NOTICE OF DECISION

SUBDIVISION / CLASS 2 ADJUSTMENT CASE NO.: SUB-ADJ19-03

REQUEST: A tentative subdivision plan to divide approximately 9.63 acres into 48 lots ranging in size from 4,428 square feet to 11,492 square feet including Alternative Street Standards request to increase the street grade from 12% to 15% for five street intervals and 50-foot right-of-way, where 60-feet is required; and a zoning adjustment to re-designate the front property lines for Lots 8, 19, 34, 43 and 44.

**BEFORE THE PLANNING ADMINISTRATOR
OF THE CITY OF SALEM
(SUBDIVISION PLAT NO. 19-03)**

TENTATIVE SUBDIVISION PLAN

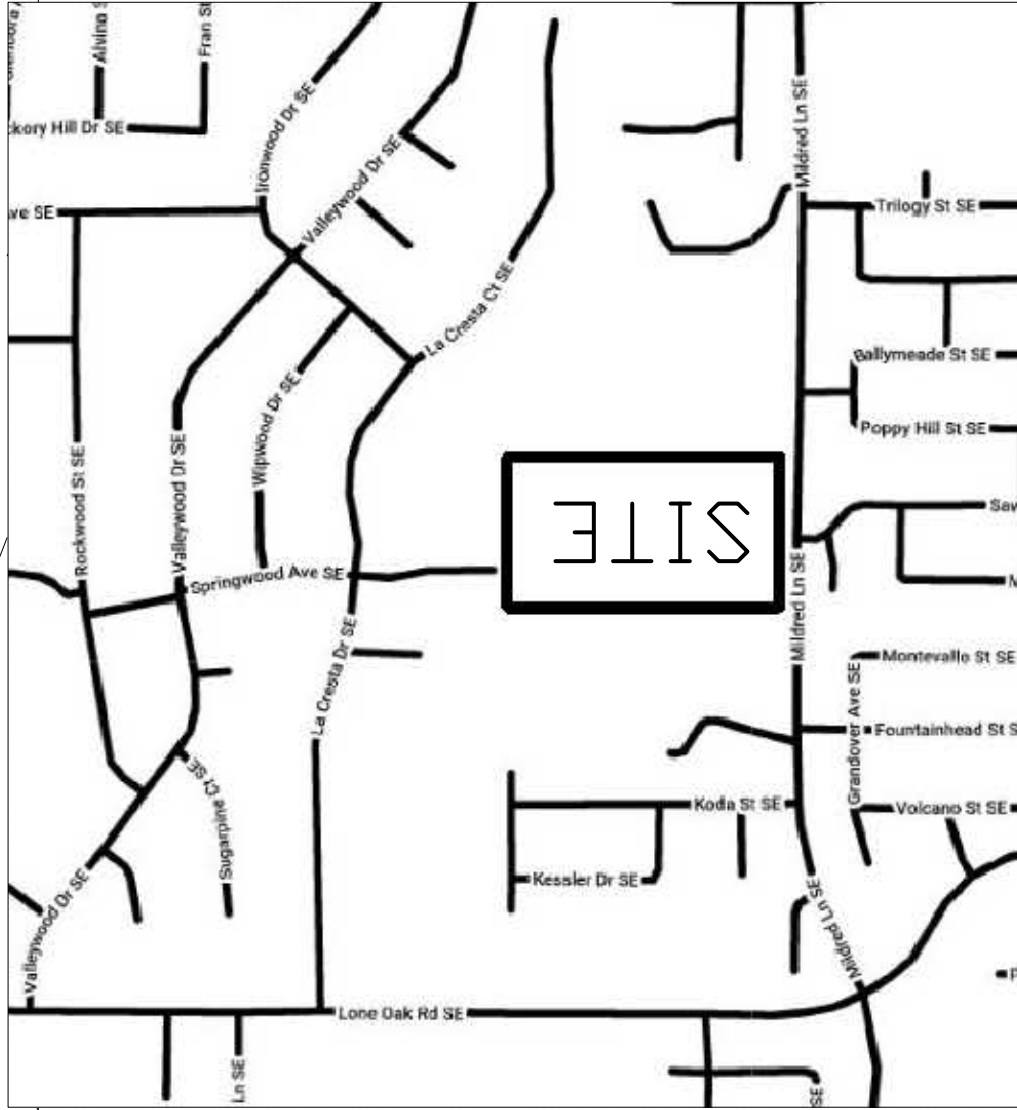
As shown on the applicant's tentative subdivision plan, the proposed lots, with exception of the proposed flag lots (Lots 5, 6, and 7), exceed the minimum 40-foot street frontage requirement. Proposed Lots 5, 6, and 7 are flag lots without the minimum frontage on a street. These proposed lots conform to the flag lot standards of SRC 800.025.

SRC 800.025 (Flag Lots): Proposed Lots 5, 6, and 7 are flag lots. Subsections (a) and (b) specify that minimum lot area and dimensions for a flag lot shall be calculated exclusively of the flag lot accessway. All proposed flag lots exceed the minimum lot area and dimensions exclusive of the flag lot accessway. The applicant is requesting an adjustment to change the front property line of Lot 8 to the west property line (easement line), which would allow access to all four lots. In addition the applicant is requesting an adjustment to designate the south line for Lot 19 as the south. Lot 19 has adequate frontage and is not considered a flag lot.

The tentative plan shows an easement width of at least 25-feet wide, however, plans do not indicated the paved width of each accessway. To ensure this standard is met, the following condition shall apply:

Pursuant to subsection (c), street grade for of a local street shall not exceed 12 percent. The applicant has provide street profiles and a written statement that all streets have been designed not to exceed 12 percent meeting this standard. The applicant does not need an alternative street standard for increased grade.

Condition 3: Prior to Final Plat approval, the flag lot accessway serving Lots 5 through 8 shall be paved in accordance with the requirements of SRC 800.025(c), Table 800-1, for a residential flag lot accessway serving 3 to 4 lots.

Condition 4: Lots 1 through 4 shall not have access to the proposed access easement.
